Department of Energy
Washington, DC 20585

B. J. Youngblood
Chief, Operations Branch
Division of High-Level Waste Management
Office of Nuclear Material Safety
and Safeguards
U. S. Nuclear Regulatory Commission
Washington, D.C. 20555

RESPONSE TO TECHNICAL ITEMS REGARDING ADEQUACY OF SITE CHARACTERIZATION PLANS
FOR THE SOUTHERN PART OF THE YUCCA MOUNTAIN SITE

Figure 6-5. Site topographic map.

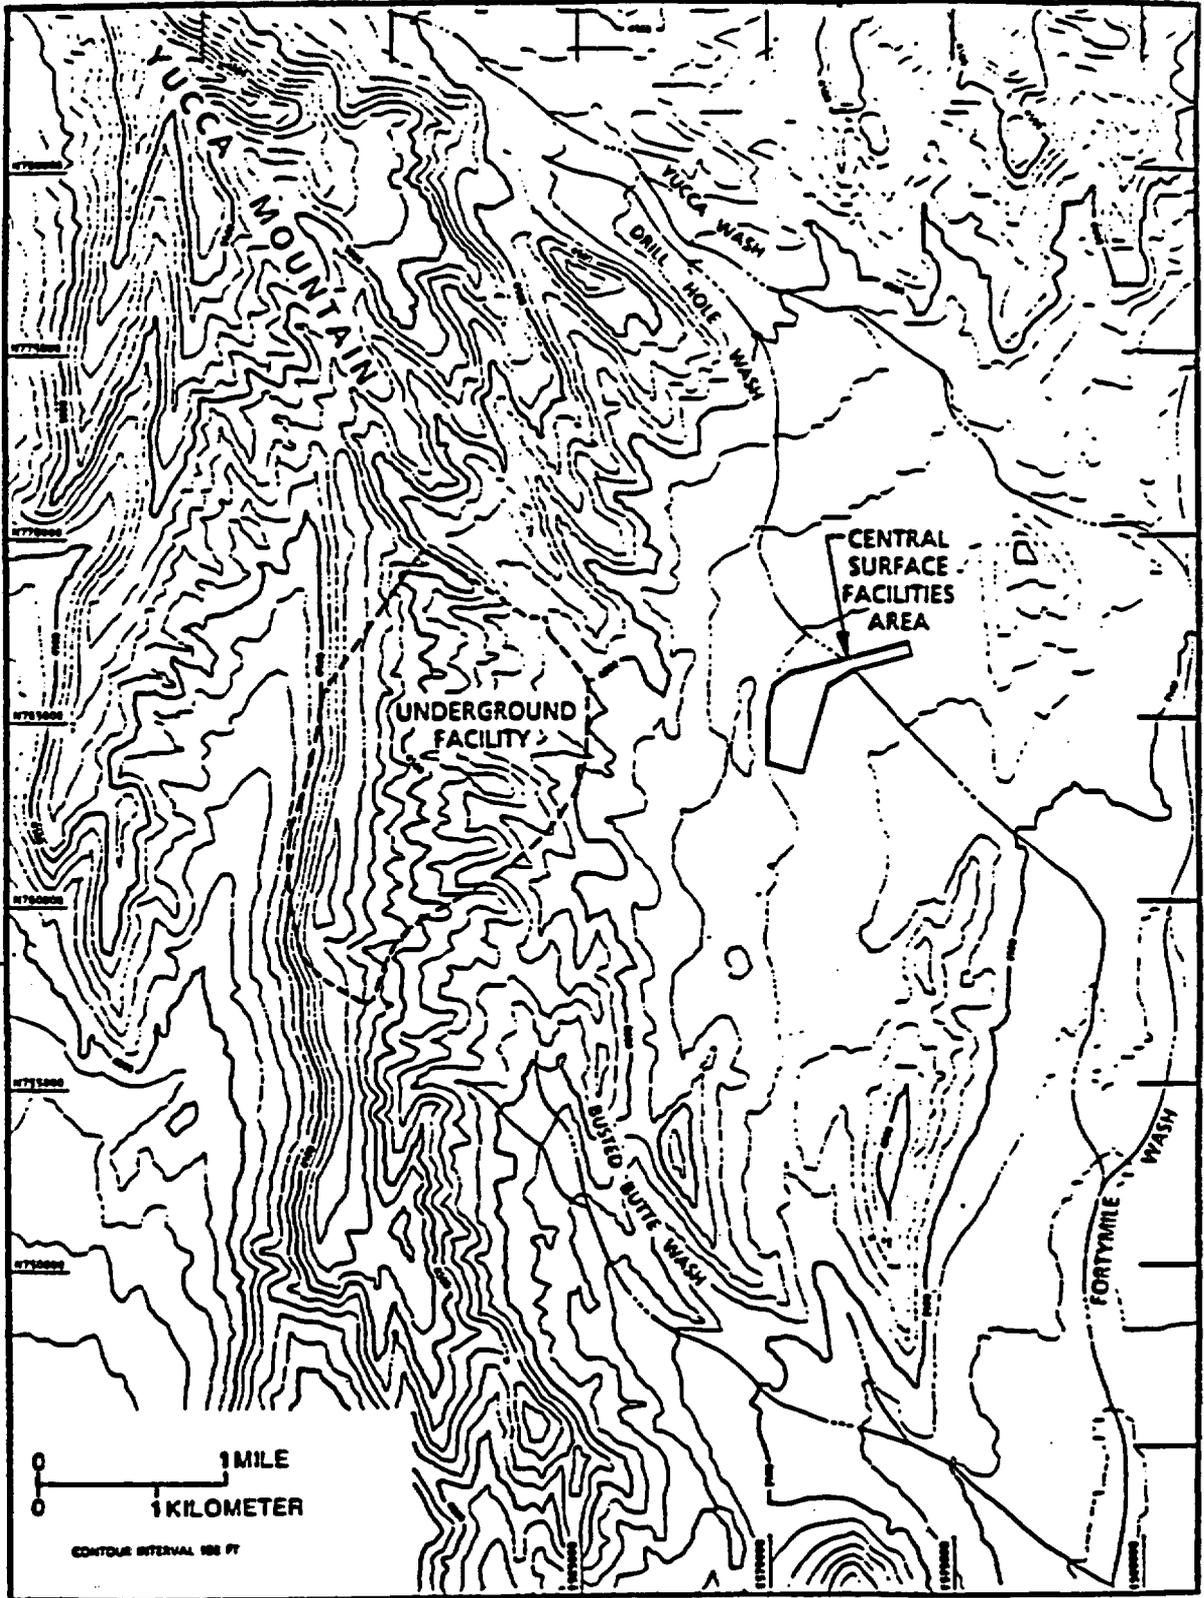
All of the comments grouped above are related to the premise that the repository block includes the more highly faulted southern area. As explained in the overview (enclosure 1) this is no longer the case. The repository outline is defined by the repository perimeter drift shown on attached figures 2, 3, and 4. Extensive surface-based and subsurface site characterization activities will be conducted in the repository block. The more highly faulted area to the south will also be characterized as part of the pre- and postclosure tectonics, rock characteristics, and hydrology programs.

Firstly, a meeting between DOE, NRC and the State of Nevada on changes to the Exploratory Shaft Facility (ESF) was held on April 14-15, 1987 in Las Vegas, Nevada in which the five proposed changes to the ESF presented by the DOE during that meeting were agreed upon by signature to the meeting summary. The results of that meeting together with consideration of site data have led to the development of an SCP-Conceptual Design Report (CDR), summarized in Chapter 6 of the SCP, that includes a major change in the perimeter drift to specifically exclude the densely faulted southern area identified in the Nevada Nuclear Waste Site Investigations (NNWSI) Environmental Assessment (EA) and in earlier design bases. The repository area as shown in the EA (DOE, 1986, Figure 3-8) is attached as Figure 1. The current repository outline is shown on Figure 6-5 and Figure 8.3.1.4-12 from the draft SCP (Figures 2 and 3, attached).

Figure 8.3.1.4-13. Conceptual example of additional phased systematic coring.

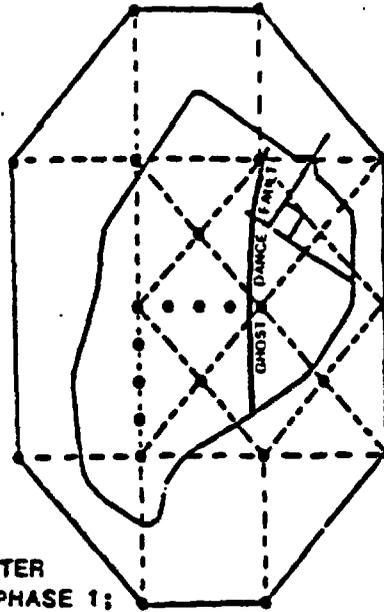
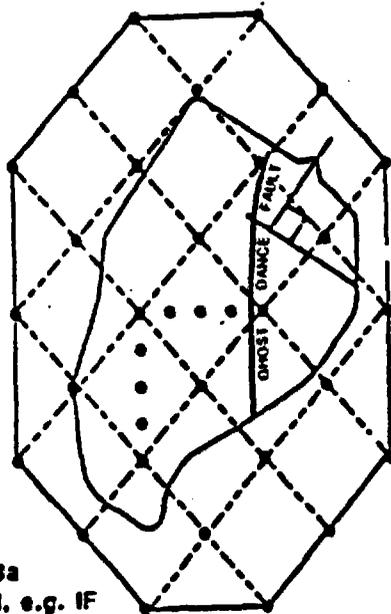
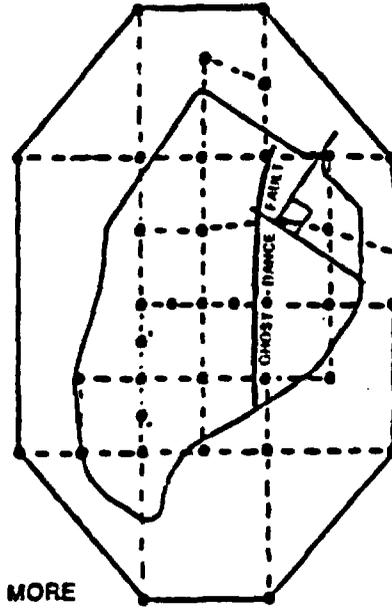
The NRC staff comment indicates that data from several boreholes and coreholes in the more highly faulted southern part of the site may not be suitable for use in the licensing process because these data may have been obtained prior to the initiation of an appropriate Quality Assurance (QA) program.

Although the southern area is no longer a part of the repository, the DOE has been evaluating the qualifications of presently existing data for use in a license application. The available data and locations of boreholes will be further evaluated after the first phase of drilling to decide on locations for additional boreholes to reduce uncertainty in the information used in the license application. Figures 3 and 4 (attached) from Section 8.3.1.4 of the August 17, 1987 draft of the SCP illustrate potential sequences of the phased systematic coring program.
